- DATE:** 5/10/2023
- APPLIES TO:** This service bulletin applies to certain 2022 model year, Metro Star model Emergency Response chassis cabs built between January and April 2022.
- CONDITION:** Changes based on new product testing to improve steering geometry and reliability.
- CORRECTION:** Replace steering assist cylinder bracket, officer side steering arm, assist cylinder steering hose, and install frame rail reinforcement.
- LABOR ALLOCATION:** 14 hours
- CLASSIFICATION:** V3
- PARTS NEEDED:**

**Figure 3.1**

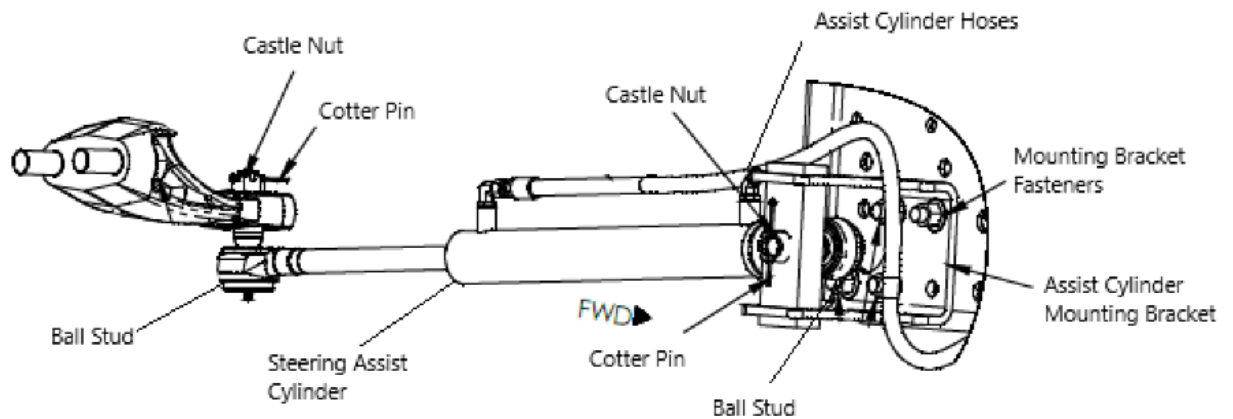
- 1) Remove steering assist cylinder and mounting bracket.
  - a. Remove assist cylinder hydraulic hoses. Label hose ends for proper reinstallation.
  - b. Remove cotter pins from each assist cylinder stud.
  - c. Loosen the castle nuts 4-5 turns.
  - d. Use appropriate puller tool to unseat the ball stud from the mount.
  - e. Once loosened from the mount, completely remove the castle nuts.
  - f. Remove the assist cylinder.
  - g. Remove the steering assist cylinder mounting bracket fasteners.
  - h. Discard steering assist cylinder mounting bracket.

**Figure 4.1**

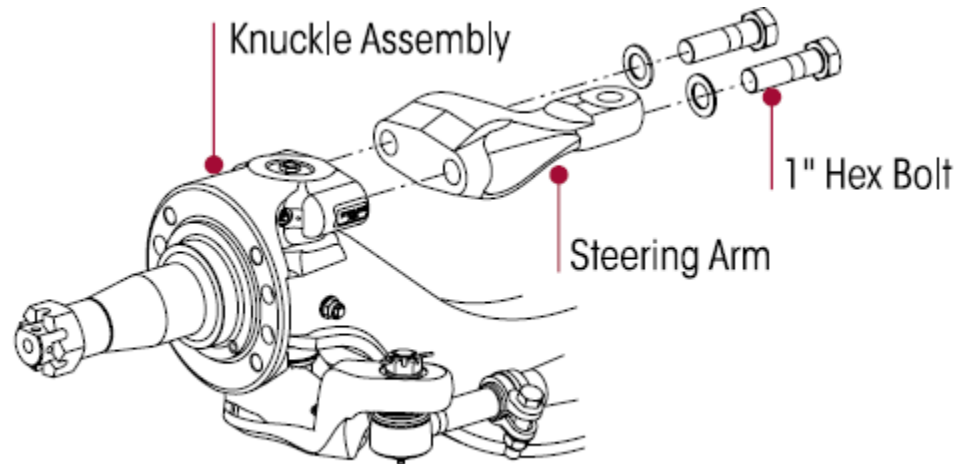
- 2) Disassemble Steering Arm
  - a. Remove the two steering arm to knuckle hex bolts that hold the steering arm to the knuckle.
  - b. Remove the steering arm from the knuckle. Gently tap the outside of the steering arm with a leather or plastic mallet if steering arm does not separate by hand.

**Figure 5.1**

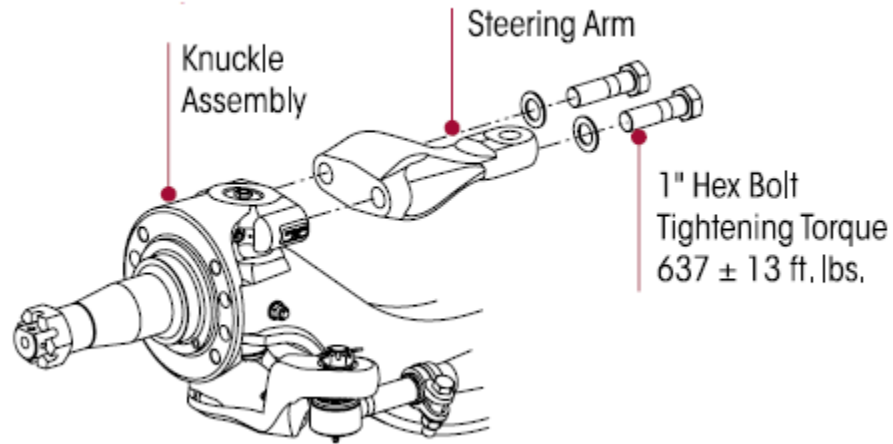
- a. Use a tap to remove old thread-locker compound from the internal threads in the steering knuckle.
- b. Use new steering arm hex bolts (pn: 30550-027) and new washers (pn: 22962-051). Coat at least half of the thread area with Loctite 680 adhesive.
- c. Insert the hex bolts through the new steering arm. Hand start the bolts into the knuckle assembly.
- d. Tighten the steering arm hex bolts to  $637 \pm 13$  foot pounds torque.

**Figure 5.2**

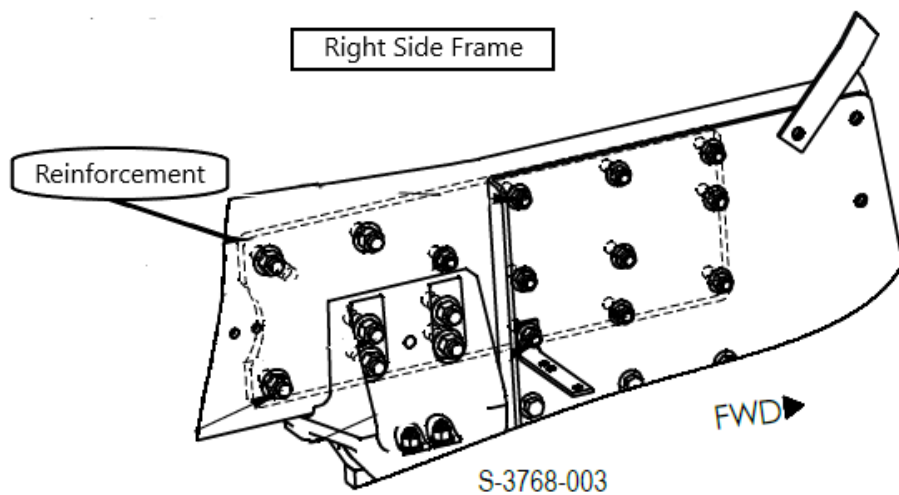
- 4) Install right side frame rail reinforcement.
  - a. Support front engine crossmember and splay rail.
  - b. Remove the fasteners shown in Figure 5.2 in preparation for the installation of the reinforcement.

**Figure 6.1**

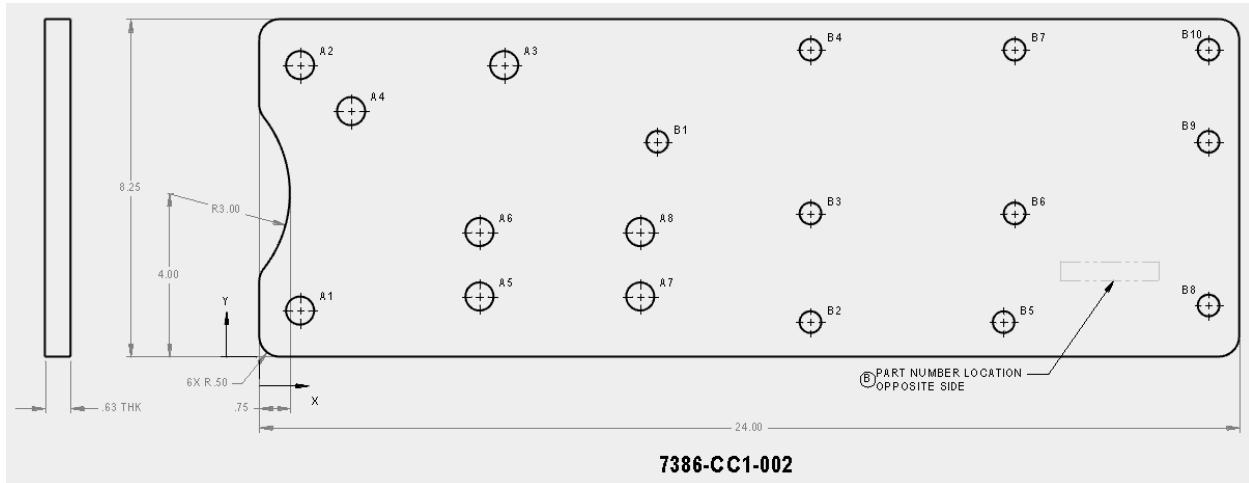
- c. Verify reinforcement plate is correct part number (7386-CC1-002) before installation. (See part number location in Figure 6.1)

**Figure 6.2**

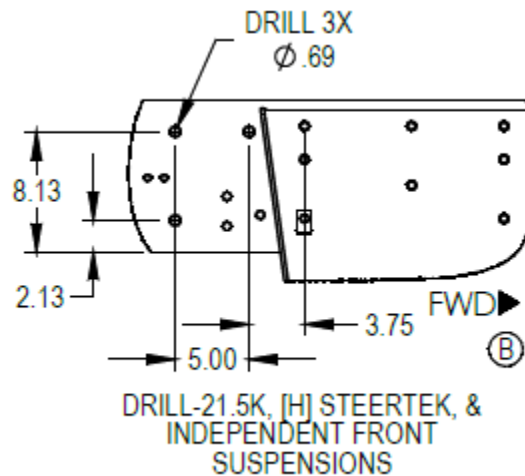
- d. Prepare frame rail for reinforcement by drilling three holes indicated in Figure 6.2

**Figure 7.1**

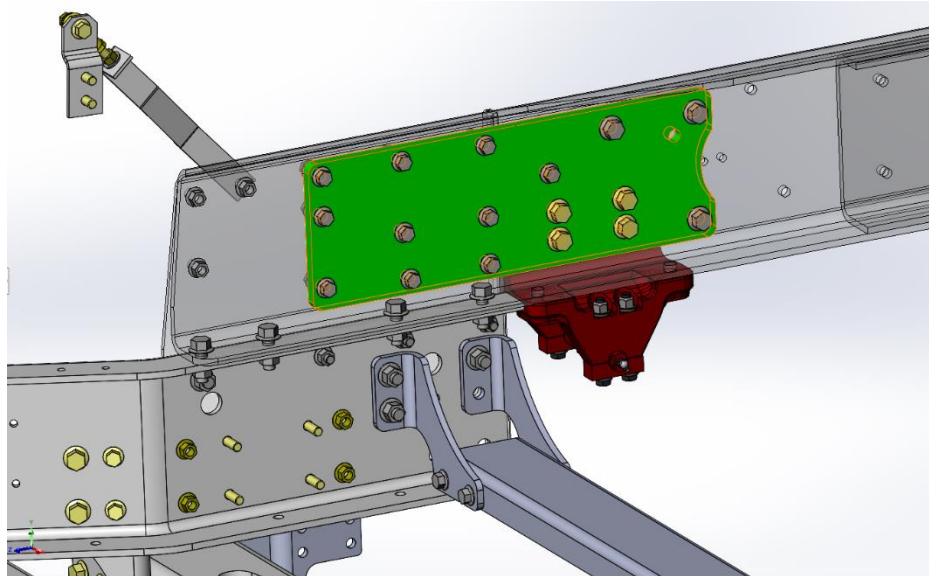
- e. Install reinforcement inside inner frame rail as shown in Figure 7.1

**Figure 7.2**

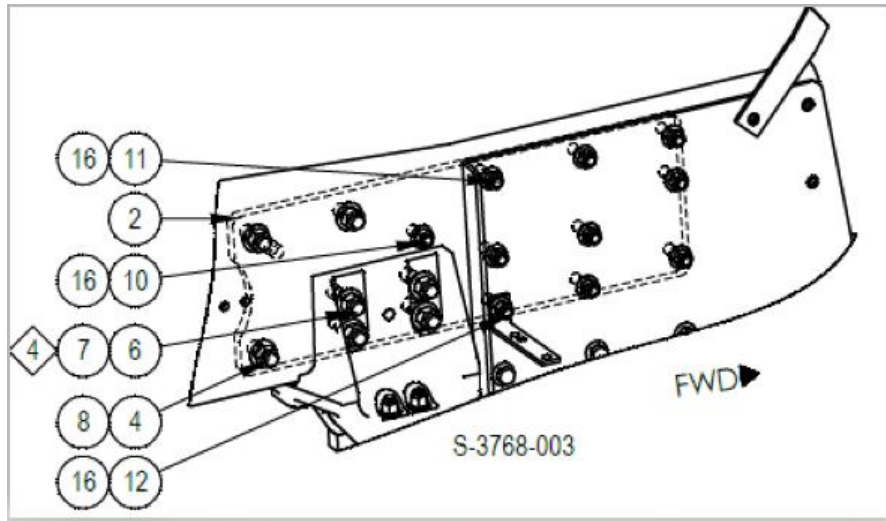
- f. Install fasteners with nuts on the outside of frame rail (*see Figure 7.2*) and torque nut side to torque spec listed in table 8.1.

**Figure 9.1**

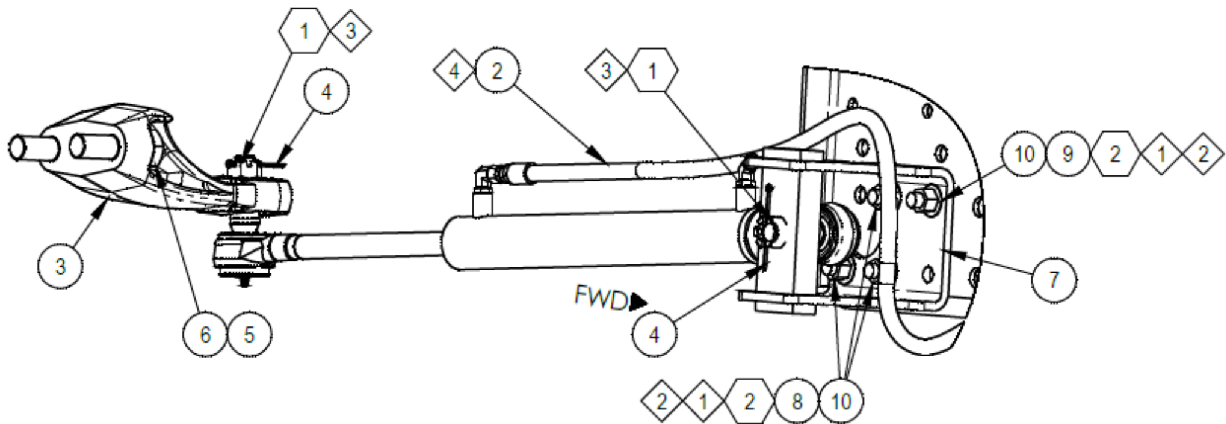
5) Reinstall assist cylinder and new bracket. (See Figure 9.1)

- a. Install new steering assist cylinder bracket part number 3161-KK1-001 (Item 7) using new bolts (item 8-9) and new nuts (item 10). Install bolts hand tight. Do not torque until after the steering assist cylinder is installed.

*Note: Bolt item 9 is longer and must be installed in the location noted in Figure 9.1.*

- b. Install 90° grease zerk (0346-BB1-001) into frame mounted end of assist cylinder, oriented as shown in Figure 6.2. Reinstall steering assist cylinder ball studs into new mounting bracket and steering arm. Install castle nuts snug.
- c. Torque each castle nut to 145 ft lbs. If castle nut slot does not align with the cotter pin hole in the ball stud initially, tighten nut slightly to align the slot with the hole. **Do not loosen to align the slot to the hole.**
- d. Install cotter pins through castle nut and ball stud and bend cotter pins over.
- e. Torque the new 5/8" diameter bolts in new steering assist cylinder bracket to 201 ft lbs.

**Figure 10.1**

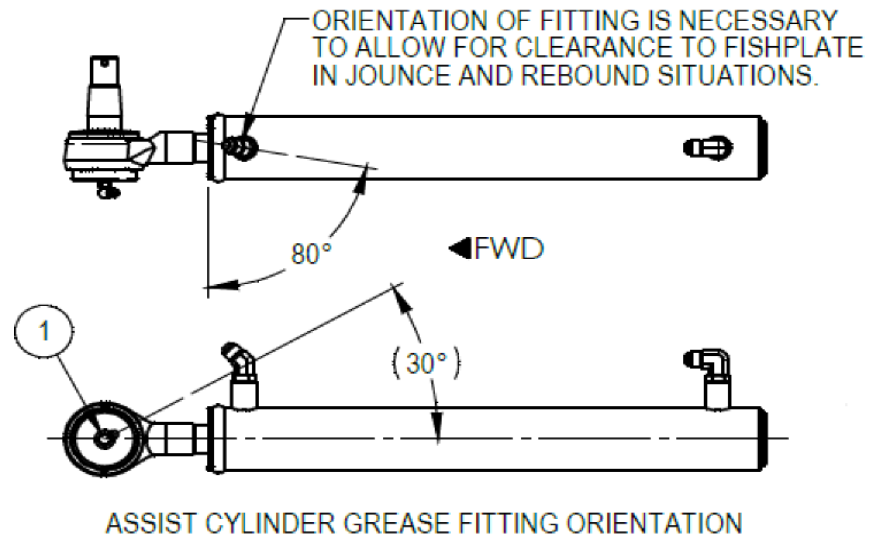
- f. Verify correct orientation of fittings on the assist cylinder before reconnecting hoses. See Figure 10.1

**Figure 11.1**

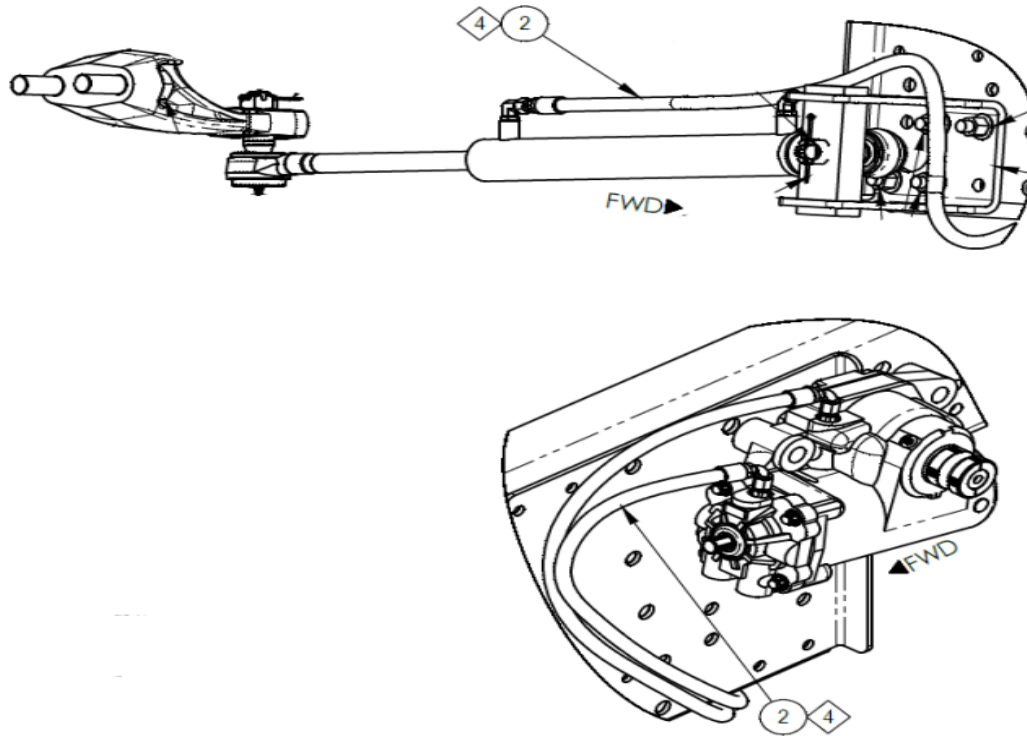
- g. Reconnect hydraulic hoses to assist cylinder, noting proper port orientation per labels installed in step 1a. Replace hose plumbed to rear assist port with longer hose to improve routing (06W-06JA06JB108). Also, refer to *Figure 11.1* below for proper hose orientation.
